Re: Initial Submission Review – Queen of Peace Catholic Parish – Site Plan Amendment
Application Number: **DA-1165-03**
Case Number: **1988-6042-06**

Initial Submission Review

MAJOR SITE PLAN AMENDMENT

SHEET NUMBER:
1 OF 8

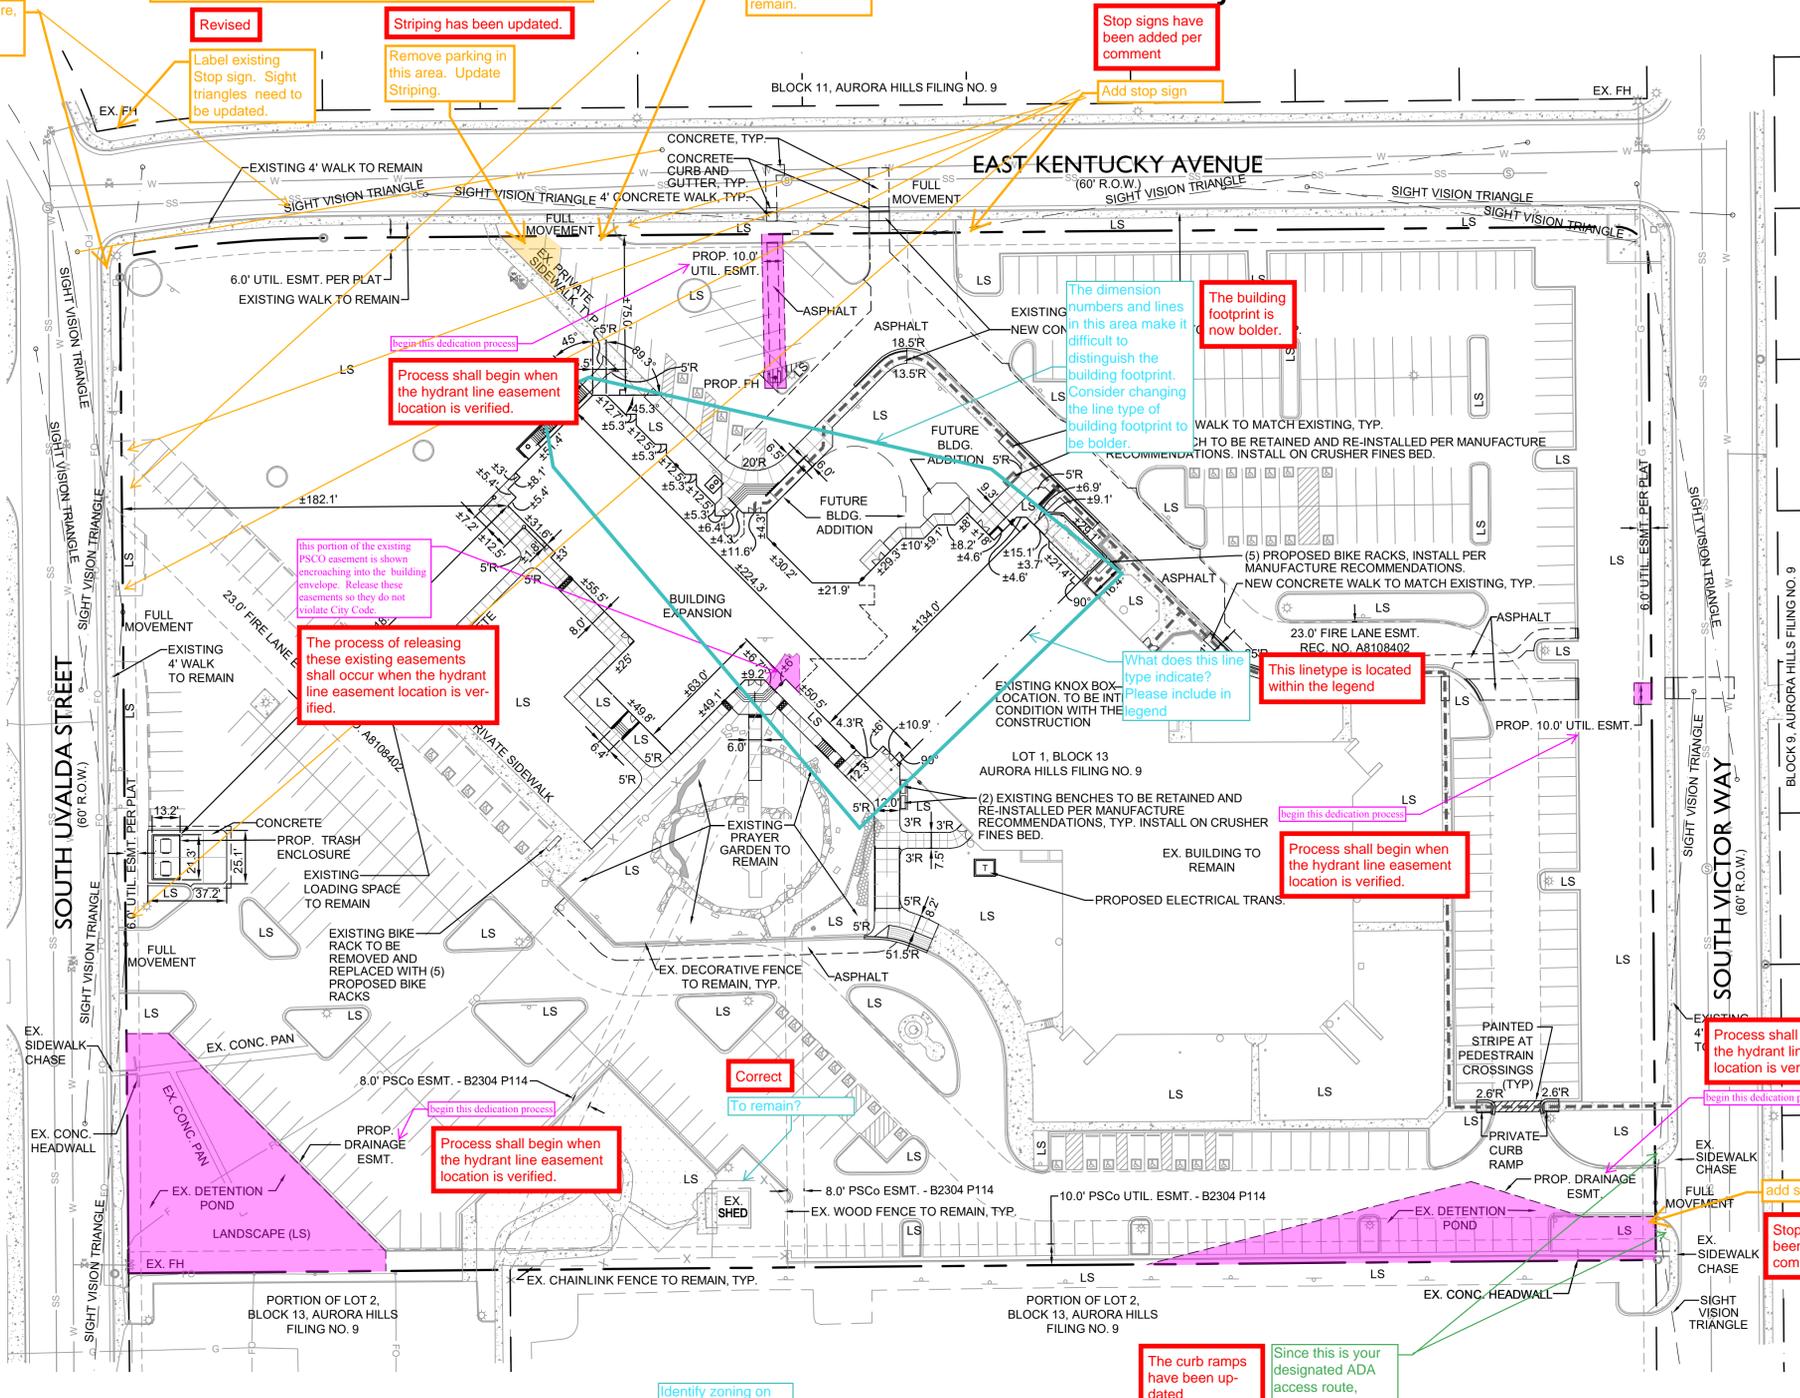
7A. The site plan will not be approved by public works until the preliminary drainage report is approved. **RESPONSE: Duly Noted.**

8D. Add the following note to the cover sheet:

“The Developer is required to install stop signs and street name signs at the site access points onto public streets. Signs shall be furnished and installed per the most current editions of The Manual on Uniform Traffic Control Devices (MUTCD) and City Standards.” **RESPONSE: This note has been added to the plans.**

This project is an amendment to the originally approved site plan, no new signatures should be provided. Remove Signature blocks

Please include photometric Plan for review.

It could be helpful to revise the data block and add an additional column so that there could be clear, side by side info for the existing conditions on the site and those proposed as part of this project.

2A. Please remove the signature block from the cover sheet. As this project is a site plan amendment, these sheets will be added to the originally approved plan set, which has signatures. No new signatures should be recorded. **RESPONSE: The Signature blocks have been removed.**

Per Conversations with Fire/Life Safety Mike Dean, No Photometrics Plan is required

The two existing signs are to remain, no new signs are proposed for this phase. Existing data has been added to the chart.

This note has been added to the plans

SHEET NUMBER:
2 OF 8

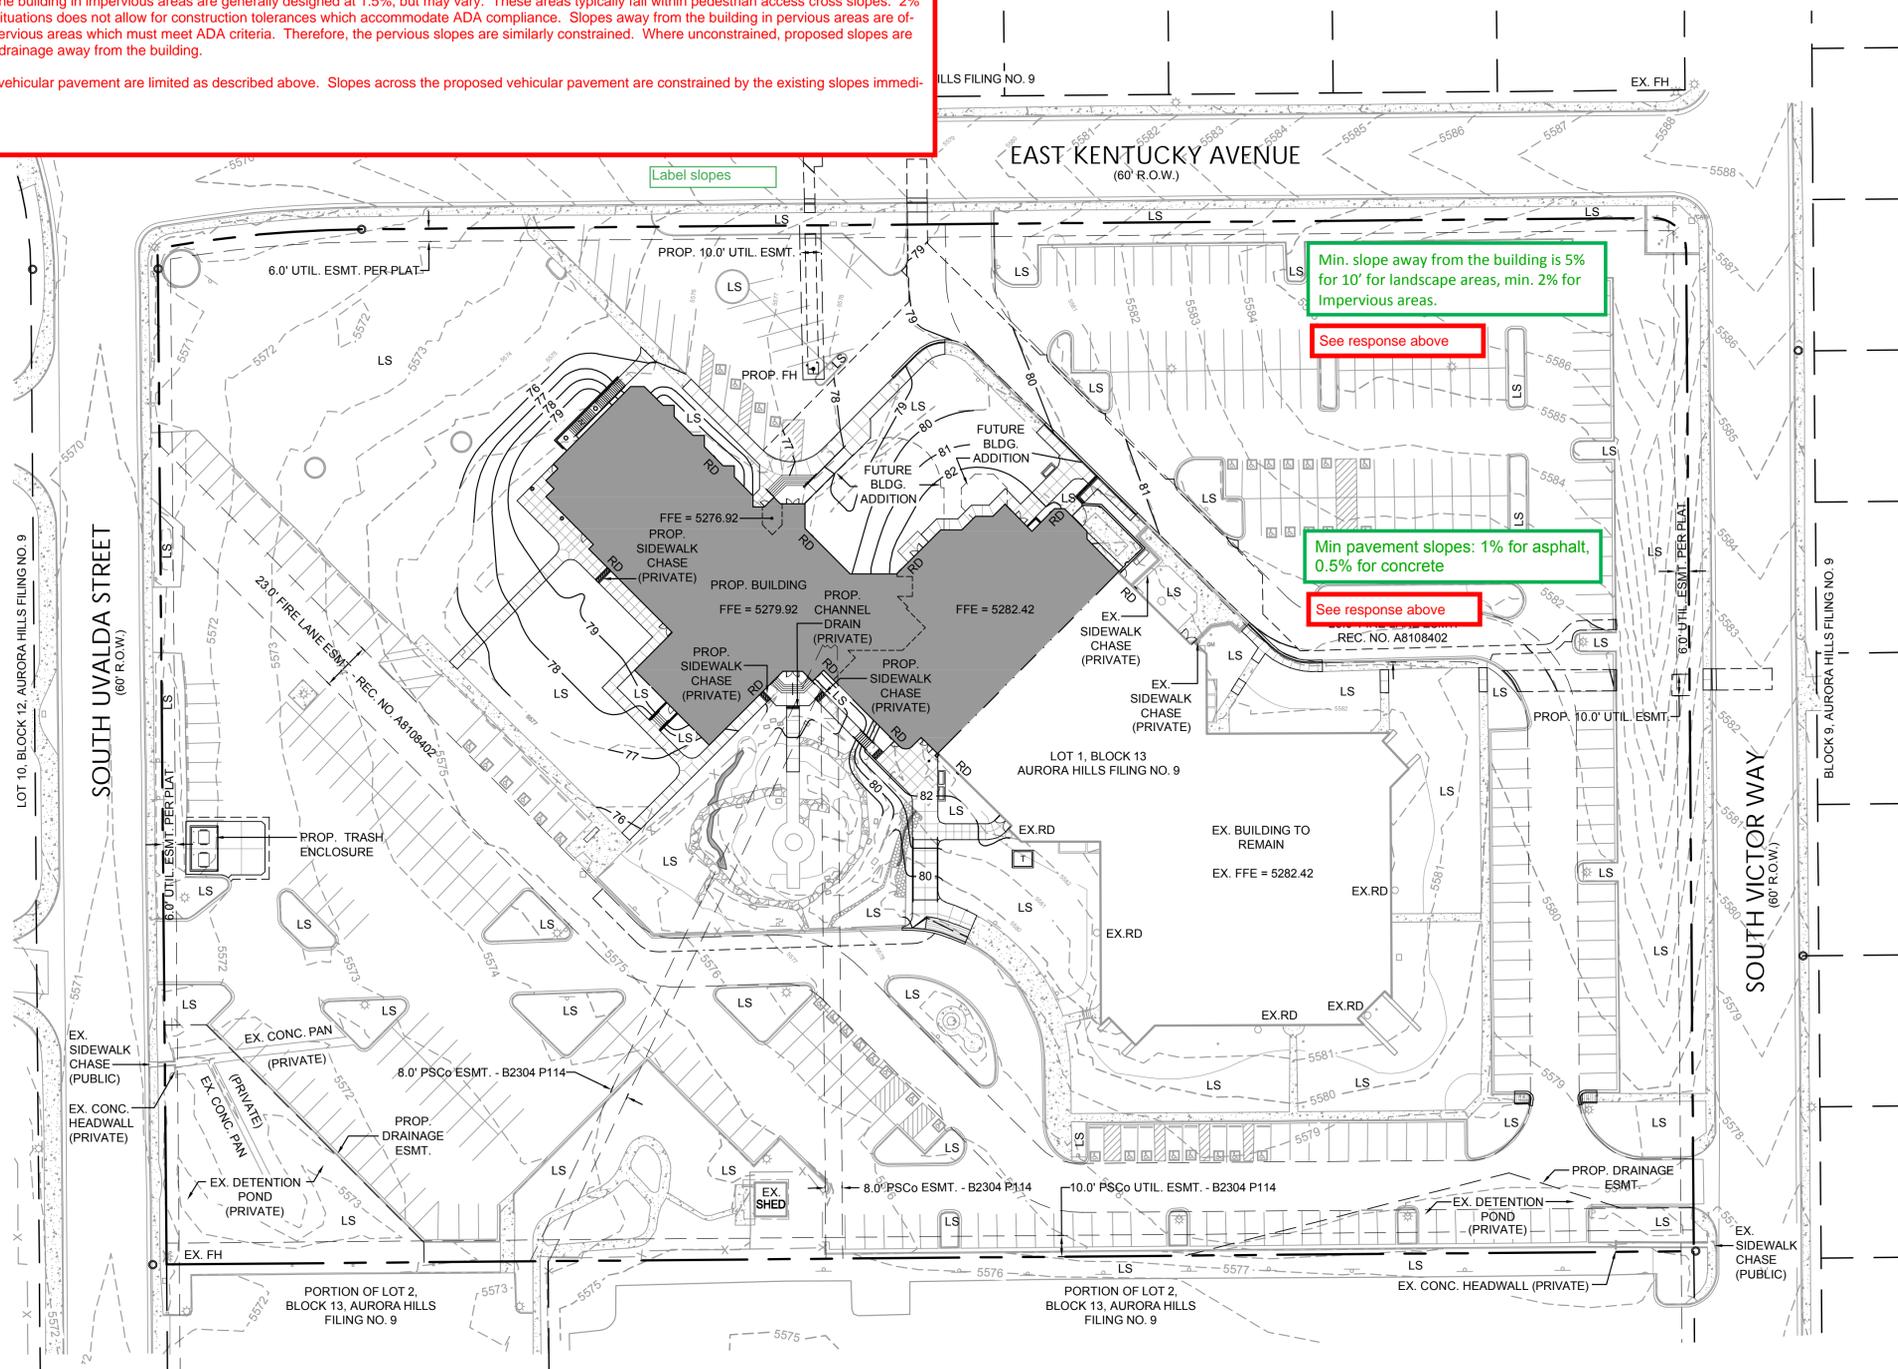
2E. The boxed area on sheet 2 is rather crowded and it is difficult to distinguish what is the building footprint and what is a building dimension. Please consider altering one of the line types throughout the plan so that this becomes easier to read. **RESPONSE: The building footprint is now bolder.**

7B. Please update the curb ramps at the entrance point located at the southwest corner of the site, as this is the designated ADA access route. **RESPONSE: The curb ramps have been updated.**

8A. Add stop signs in the indicated locations and label all existing stop signs. **RESPONSE: Stop signs have been added per comment.**

8B. Sight triangles are needed for all existing access points that are to remain. Sight triangles are based on the locations of stop signs. Remove sight triangles from turning points that do not have stop signs where requested. Sight triangles should also be shown on the Landscape Plan in accordance with COA standards. **RESPONSE: Sight Triangle's have been revised.**

8C. Remove the parking in the indicated area as it impedes the full movement access point. Update striping. **RESPONSE: Striping has been updated.**

SHEET NUMBER:
3 OF 8

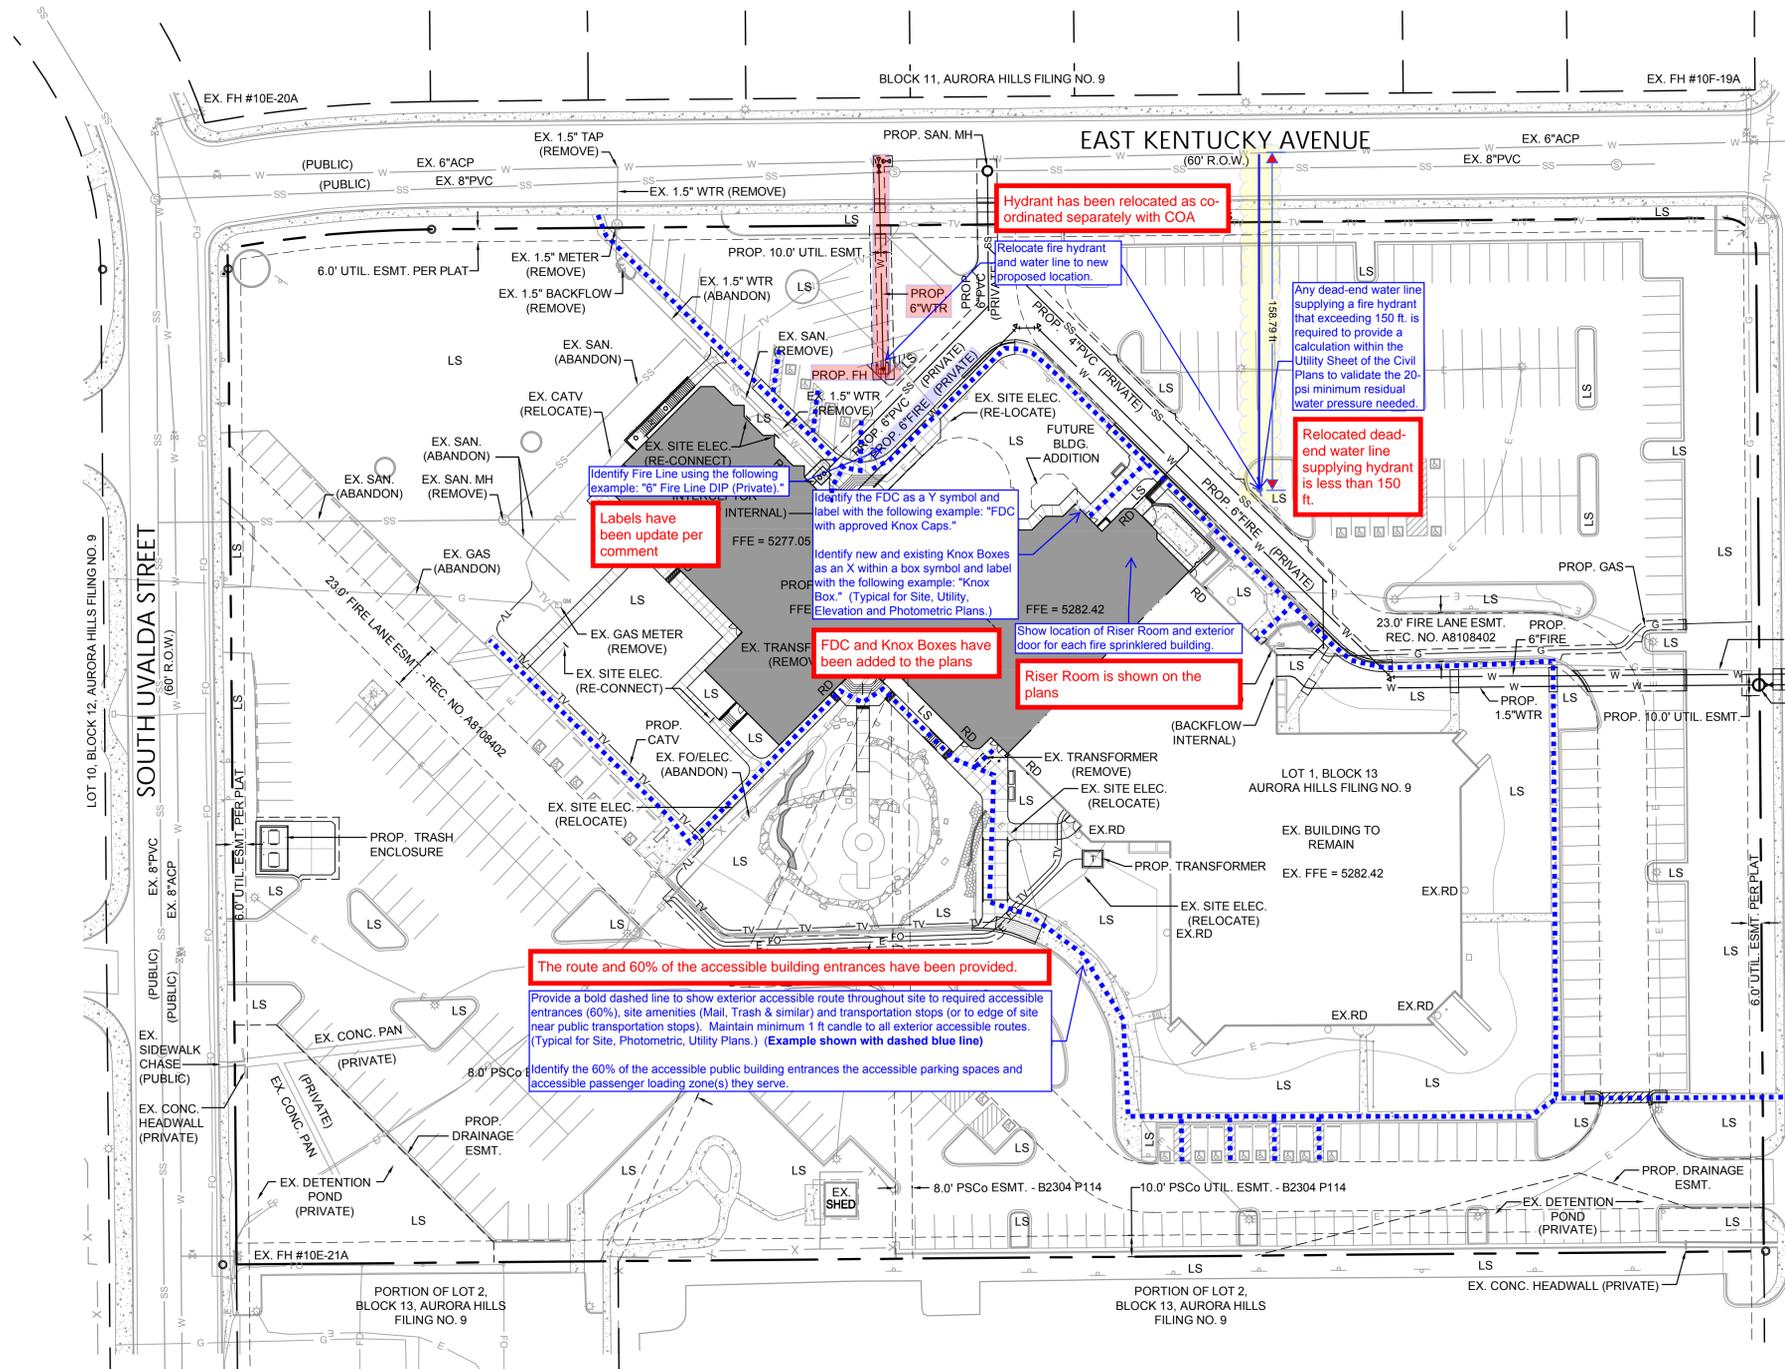
7C. Label all slopes. Please note the minimum permitted slope away from the building is 5% for 10 feet for landscape areas and minimum 2% for impervious areas. The minimum slope for pavement areas is 1% for asphalt and 0.5% for concrete. **RESPONSE: Various representative slopes for proposed improvements have been labeled. Additional detail describing slopes for the proposed improvements including, but not limited to walks, ramps, landings, and steps will be provided with the Civil Construction Plans and can be reviewed at that time. The project represented in the plans describes a building remodel, and as such attempts to limit proposed site improvements only to those areas immediately adjacent to and impacted by the remodel. The majority of the site, including its slopes, will remain in its existing condition and therefore does not require labeling. The nature of this approach necessarily constrains design of proposed improvements to the existing condition. Various slopes have been labeled "EX" for clarity in areas where existing improvements to remain are adjacent to proposed improvements. Several areas of proposed improvements are so immediately tied to the adjacent existing condition, that their proposed slopes must match existing slopes. Slopes away from the building in impervious areas are generally designed at 1.5%, but may vary. These areas typically fall within pedestrian access cross slopes. 2% minimum in these situations does not allow for construction tolerances which accommodate ADA compliance. Slopes away from the building in pervious areas are often adjacent to impervious areas which must meet ADA criteria. Therefore, the pervious slopes are similarly constrained. Where unconstrained, proposed slopes are greater to facilitate drainage away from the building. Areas of proposed vehicular pavement are limited as described above. Slopes across the proposed vehicular pavement are constrained by the existing slopes immediately adjacent.**

Various representative slopes for proposed improvements have been labeled. Additional detail describing slopes for the proposed improvements including, but not limited to walks, ramps, landings, and steps will be provided with the Civil Construction Plans and can be reviewed at that time.

The project represented in the plans describes a building remodel, and as such attempts to limit proposed site improvements only to those areas immediately adjacent to and impacted by the remodel. The majority of the site, including its slopes, will remain in its existing condition and therefore does not require labeling. The nature of this approach necessarily constrains design of proposed improvements to the existing condition.
